Korenix JetNet PoE Switch- JetNet 4706 SOFTWARE RELEASE Notes

About This Software Version

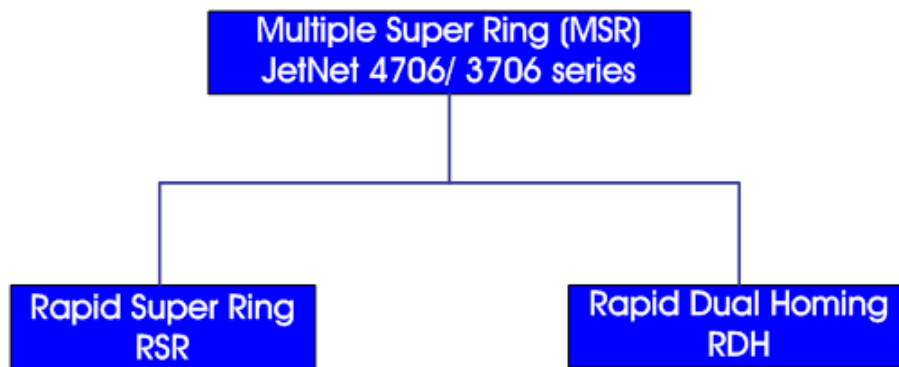
Upgrade firmware shall follow the following sequence:

- First, upgrade firmware v2.1 by JetView v1.3 or above
- Second, upgrade Boot loader v1.6.4.3 by JetView v1.3 or above
